Our Ref: 21205

6 March 2023

**RE: 4 DELMAR PARADE AND 812 PITWATER ROAD, DEE WHY
TRAFFIC RESPONSE TO RFIS**

As requested, please find herein The Transport Planning Partnership (TPPP)'s response to Council's traffic engineering comments relating to the above proposed development.

Figure 2: Dee Why Town Centre Study Extract

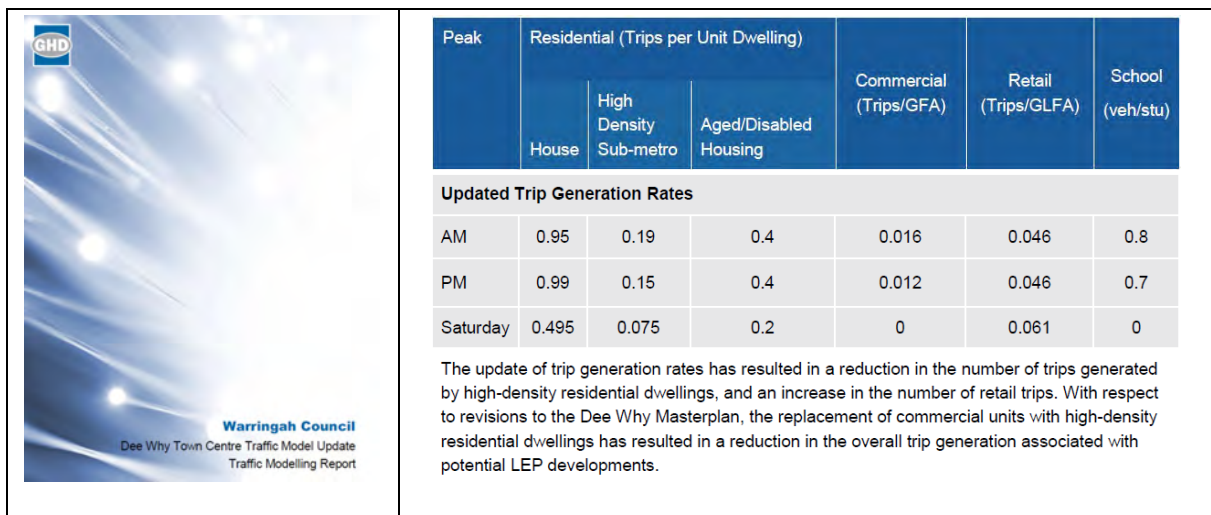
<p>Traffic Generation</p> <p>As noted in the original traffic referral comments, the applicant's traffic consultant has estimated traffic based on an optimistic assumption that the development will generate traffic at a rate consistent with similar developments located near a rail line. This is not accepted and a more realistic traffic generation rate of 0.29 trips/ residential car space in the AM peak and 0.28 trips/residential car space in the pm should be used given the absence of a rail line and the 500m walking distance to the nearest B-Line bus stop. For the revised development it is considered that more realistic trip rates from the residential component would be 0.29x235 (68) residential trips in AM peak and 0/28x235 (66) residential trips in the PM peak.</p> <p>In addition, there will be 19 AM peak retail/commercial trips and 38 PM peak retail commercial trips i.e. a total AM peak traffic generation of 87 trips/hr and a PM peak traffic generation of 104 trips/hr.</p> <p>The developer's traffic consultant has estimated the existing commercial development on the site to have generated 64 trips/hr in the AM peak and 48 trips/hr in the PM peak. Based upon the above, the PM peak traffic is estimated to increase by 56 vehicles per hour post development.</p>	<p>A modified analysis of traffic generation impacts from the development is detailed in this report under heading "Traffic Generation".</p> <p>This "Traffic Generation" section concludes that the traffic impacts will be acceptable and makes further recommendations regarding the right turn movement into and out of Delmar Parade during peak periods..</p>

TTPP does not agree with Council’s statement that the adopted trip rates are not realistic.

Furthermore, Council’s own Dee Why Town Centre Traffic Modelling Report superseded the old 0.29 rates with the new 0.19 rates as shown in Figure 2.

The update of trip generation rates has resulted in a reduction in the number of trips generated by high-density residential dwellings, and an increase in the number of retail trips. With respect to revisions to the Dee Why Masterplan, the replacement of commercial units with high-density residential dwellings has resulted in a reduction in the overall trip generation associated with potential LEP developments.

TITLE: GROUND - SWEEP PATH ASSESSMENT

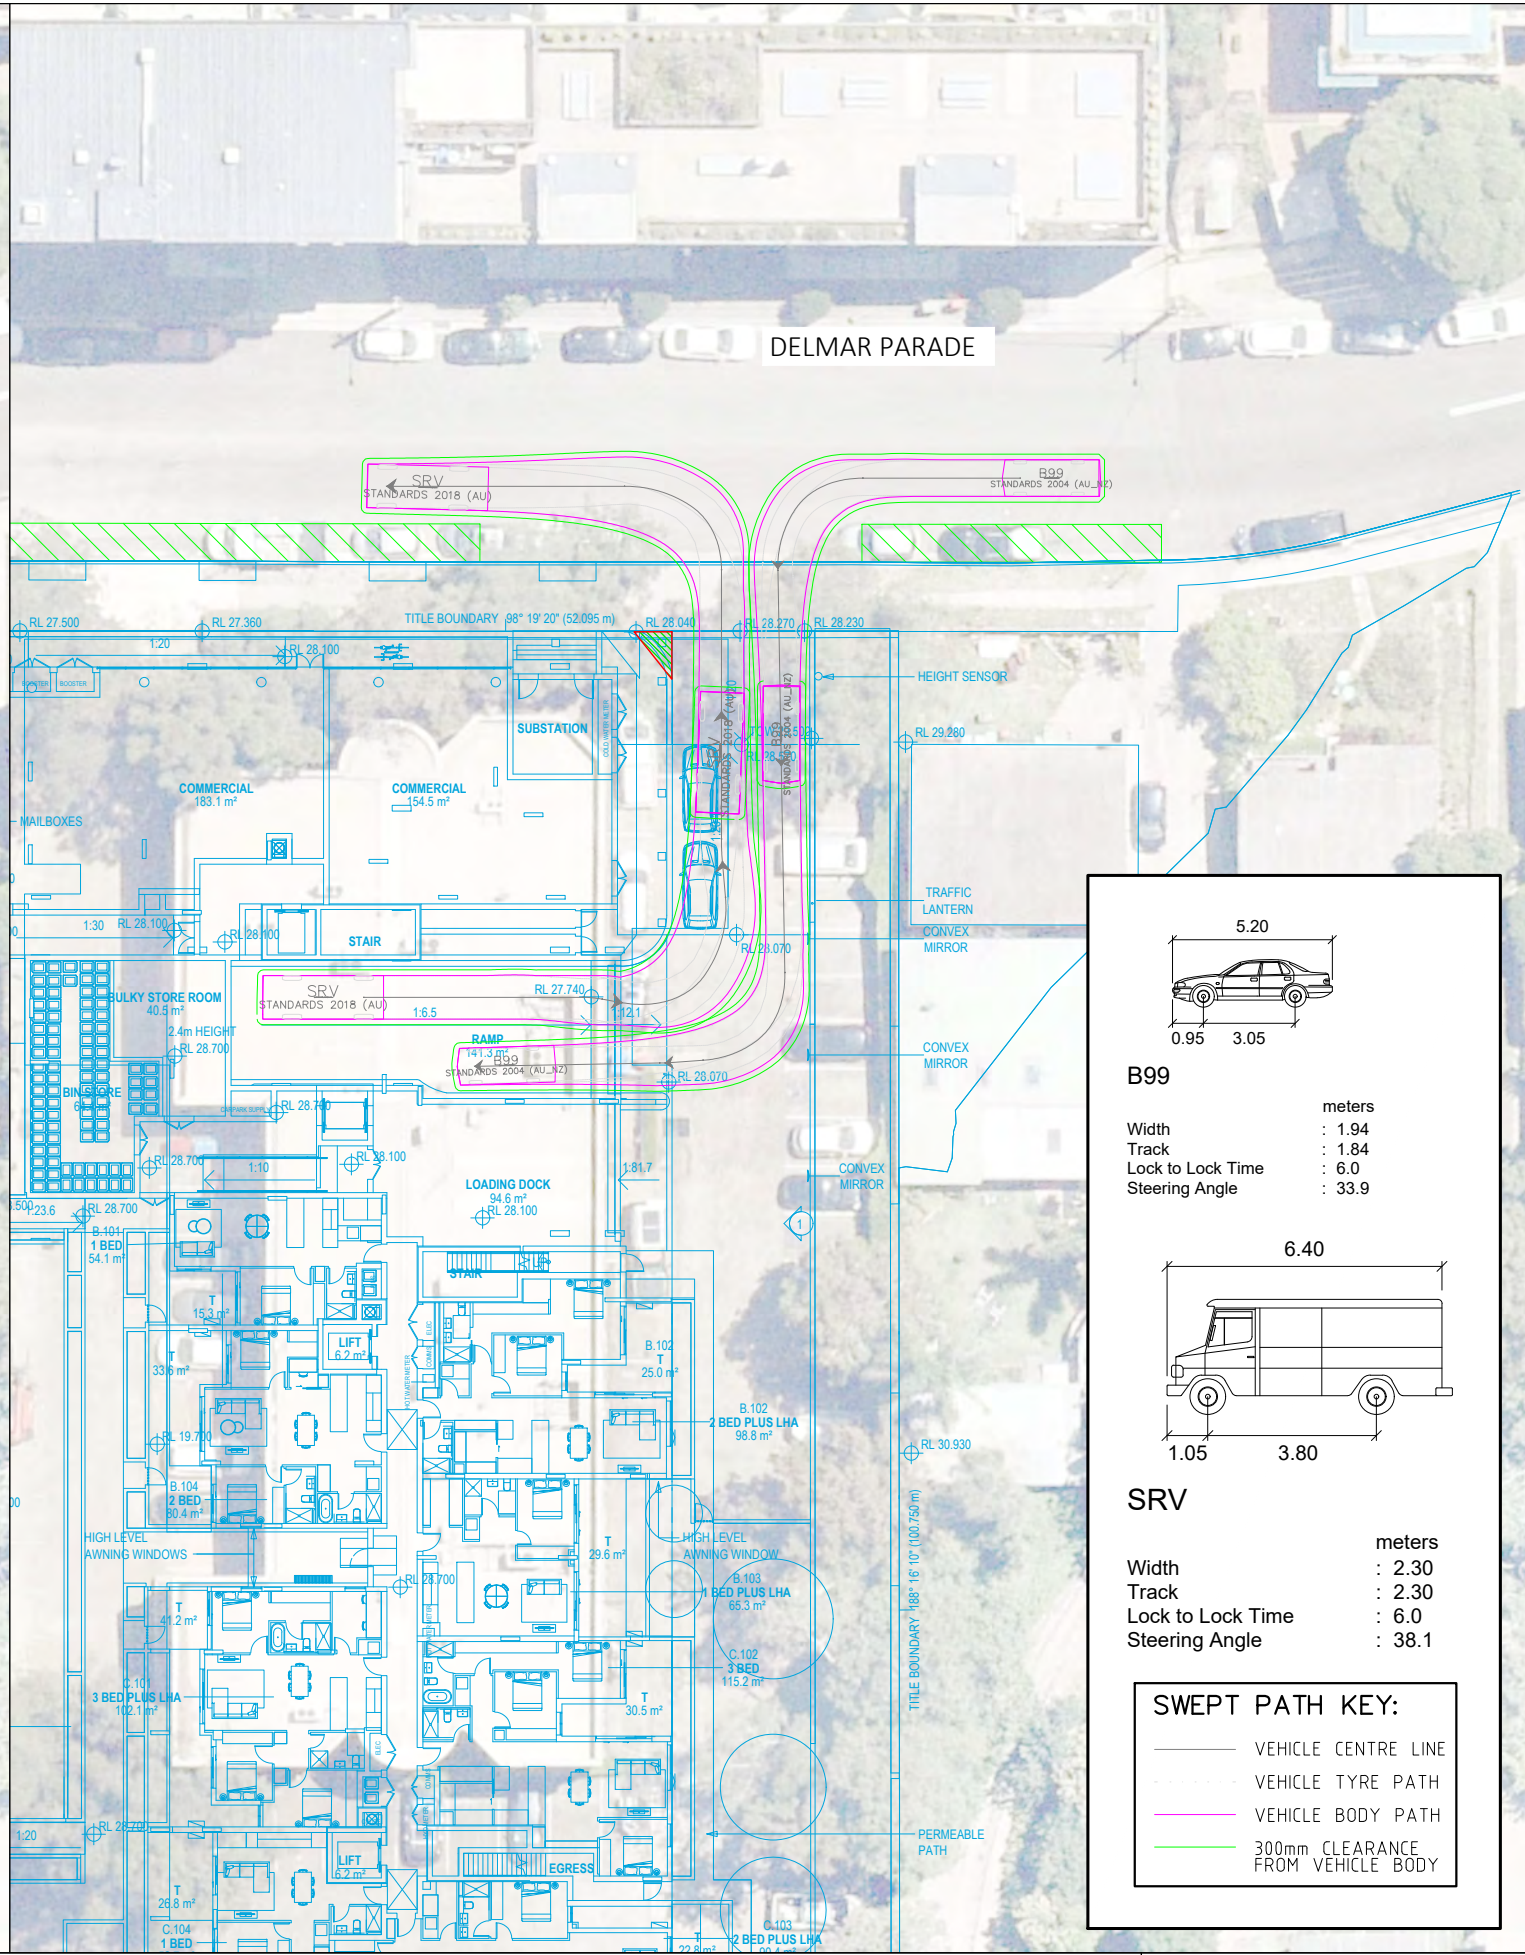
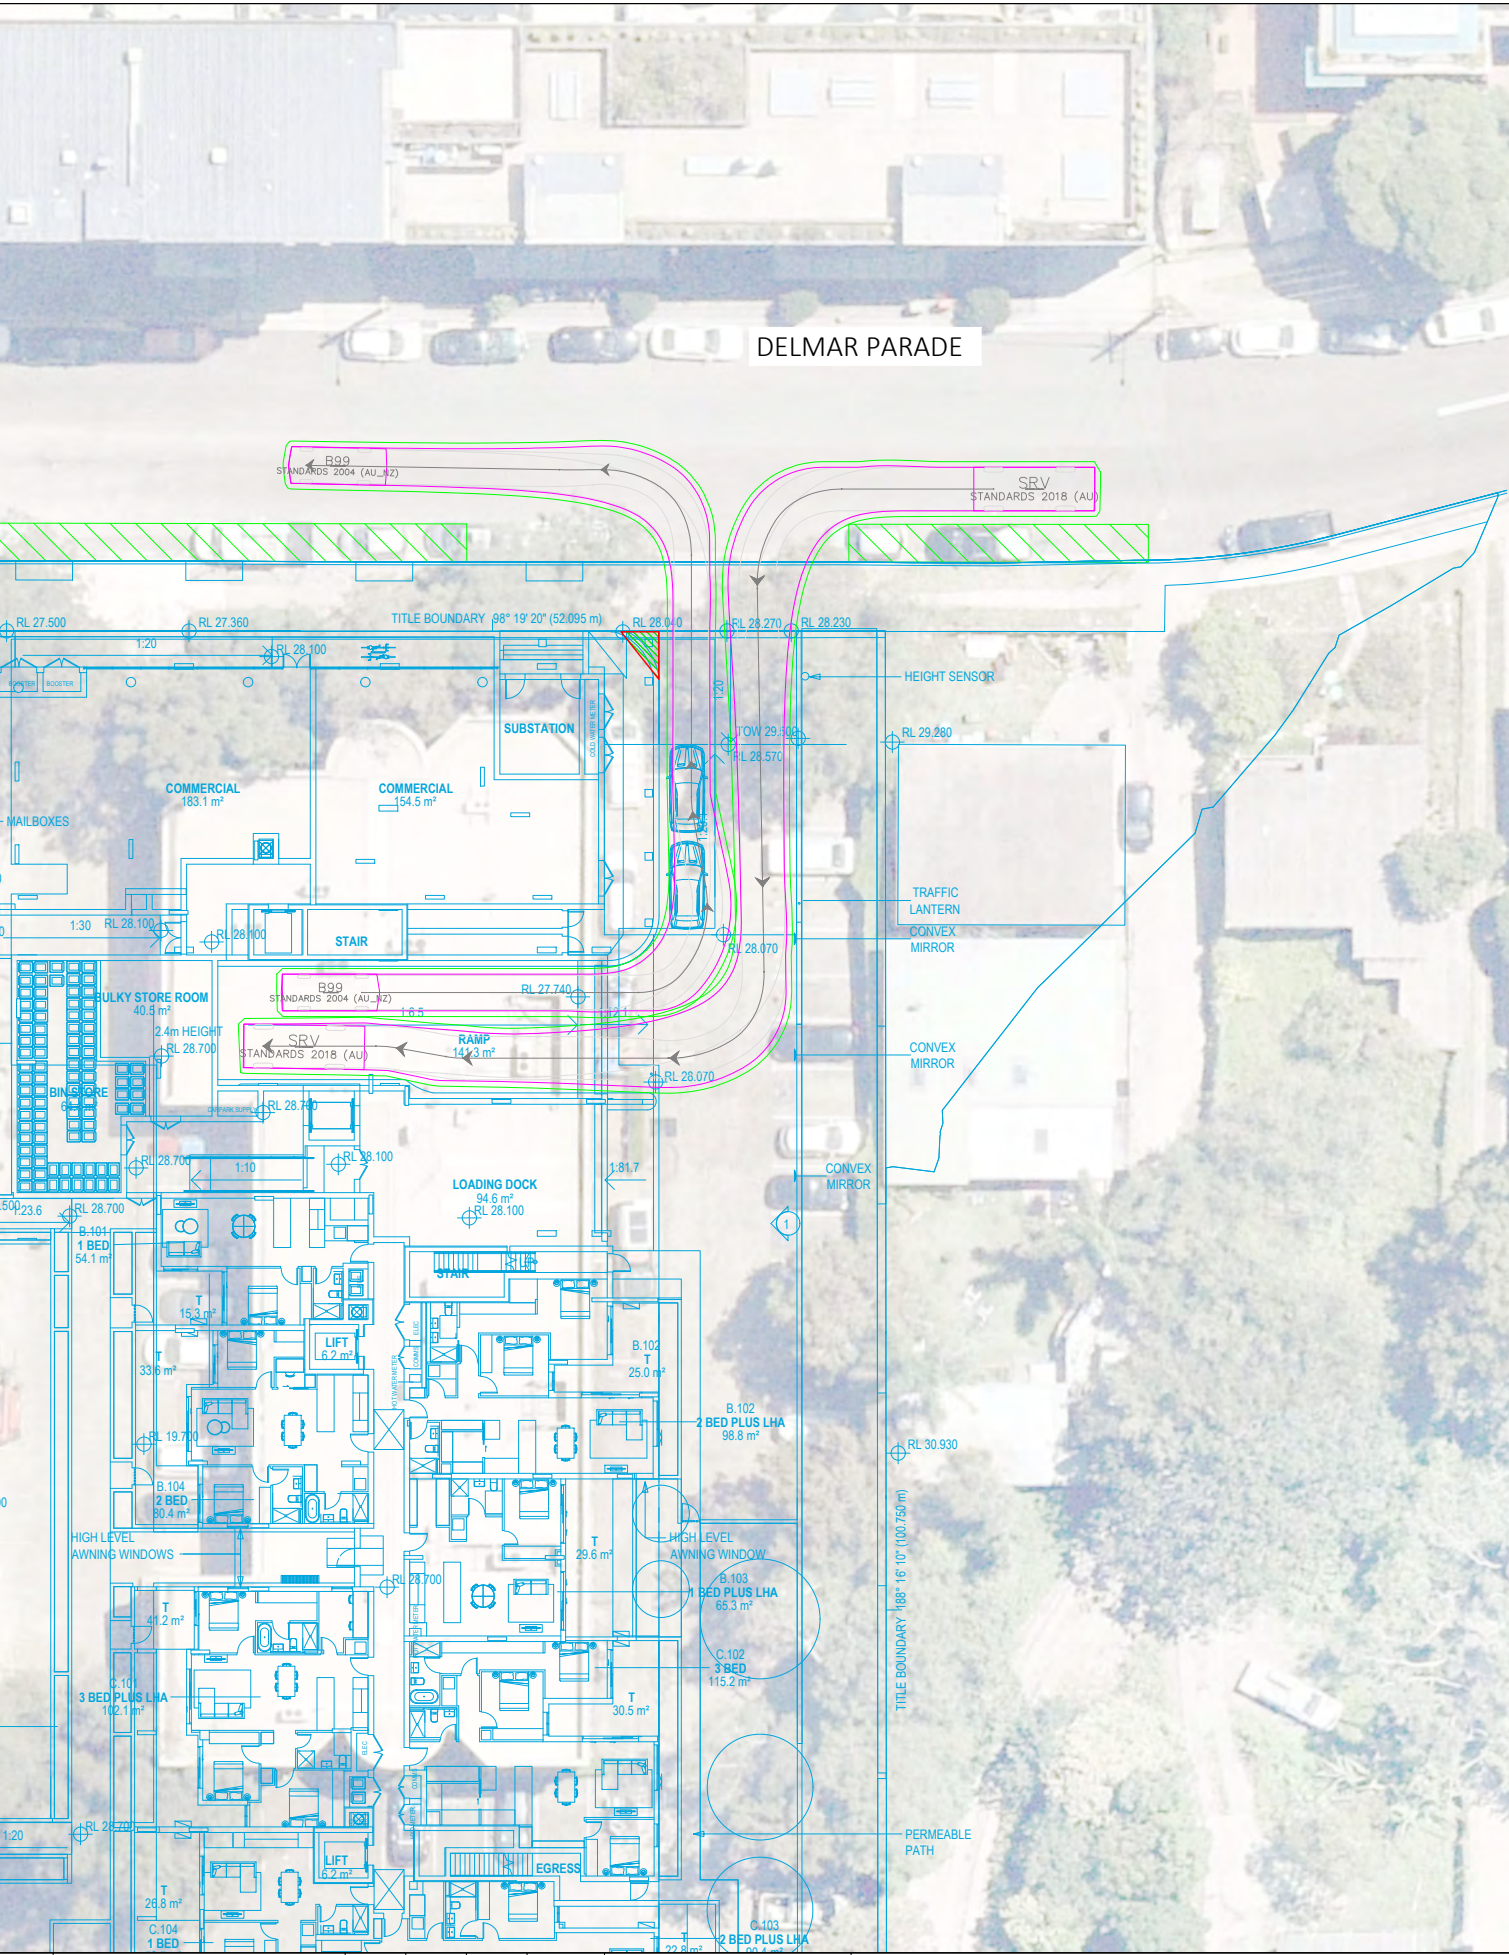
HRV Truck Egress from Ground Floor Loading Dock - unacceptable.

The proposal is for a traffic management system on the vehicle access driveway to the property that involves the use of a red light system to stop traffic flow when a vehicle is entering and leaving the ground floor loading dock.

Vehicles entering the property from Delmar Parade are stopped by the red light on the driveway a minimum of 12 metres inside the property. This is a point approximately in line with the northern side of the loading dock opening.

This is clearly unworkable as a HR truck exiting the loading dock requires the full width of the driveway to make the turn out of the dock and then still requires the full width of the driveway to exit the property. Vehicles stopped at the red light would be forced to reverse out onto Delmar Parade to allow the truck to exit the property. This clash is clearly demonstrated by the swept path diagrams provided on page 6 of Addendum Traffic Report.

During discussions held late last year between Council and the applicant it was agreed to investigate the use of a traffic light system. The traffic light system proposed is clearly unworkable and I am not convinced that this is the solution to truck access to and from the property for waste collection purposes. Provision of a separate driveway for access to and from the loading dock is the preferred outcome. This is also the position held by Council's Traffic Engineer.

Following consultation with Council, the ground floor and associated loading dock layout has been modified and the amendments have been generally supported by the Council.

This is further discussed in this report under the heading "**Proposed Modifications**".

TITLE
 BASEMENT 1 - SWEEP PATH ASSESSMENT

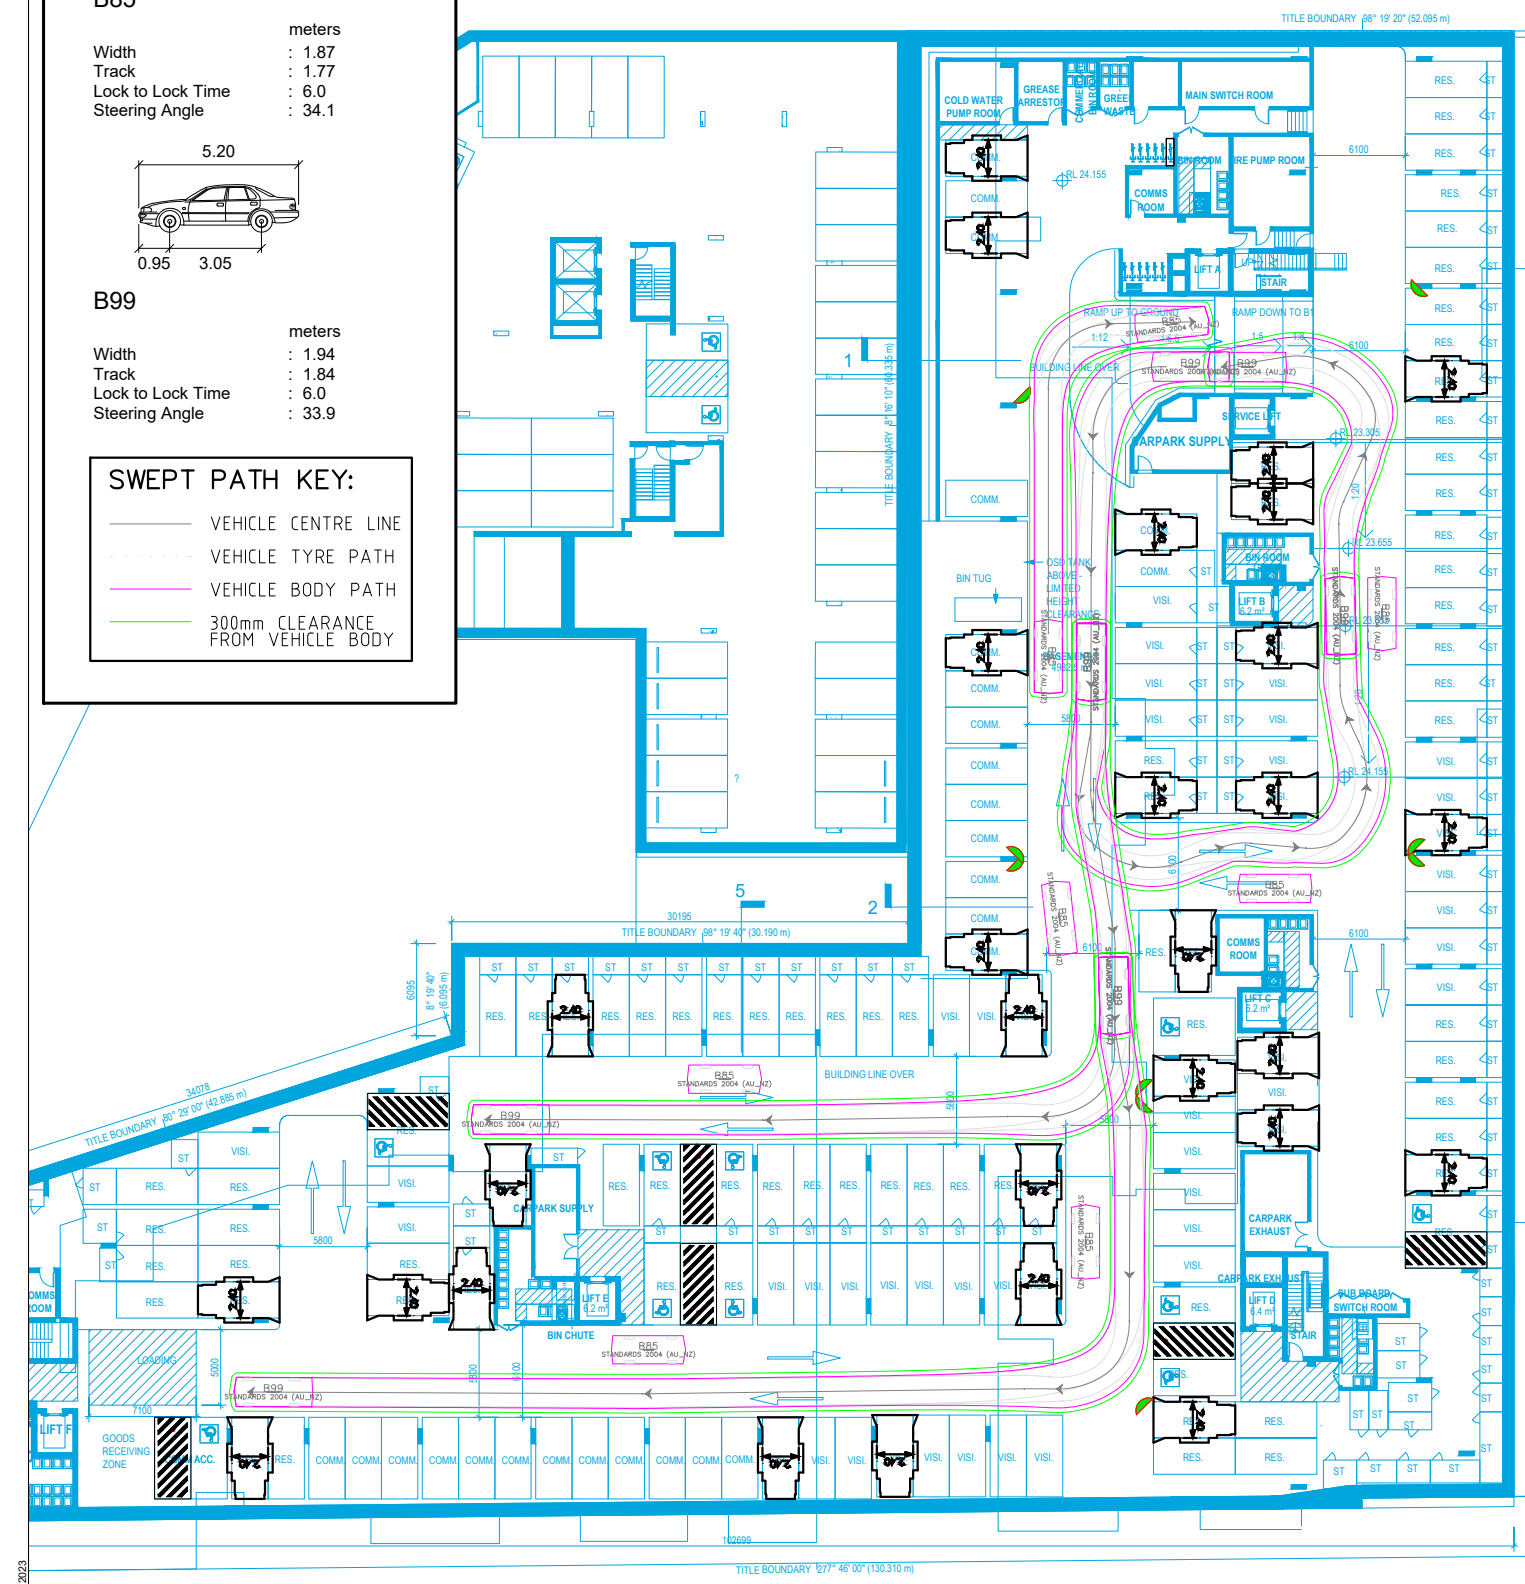
<p>Swept path plots provided in the traffic report reveal that there are a number of locations within both the basement 1 and basement 2 parking levels where the circulation area has not been designed to allow for passing of B85 & B99 vehicle as required by AS2890.1 clause 2.5.2(c). Given that there is a significant over supply of parking in terms of DCP requirements and given the number of vehicles likely to be circulating to and from parking spaces, deletion of some parking spaces and/or widening of circulation aisles to facilitate adequate passing opportunities is required.</p>	<p>If a car park is designed to accord with the Australian standard, it is often not possible for Autoturn to show that two cars can pass each other.</p> <p>However, two-way flows have been provided where sight lines are limited i.e. at the top and bottom of ramps. Within a standard circulation aisle, it is typical for two B99 cars not to pass each other at corners, however, there should be sufficient sight lines to enable drivers to negotiate access, as is the case with any typical car park.</p>
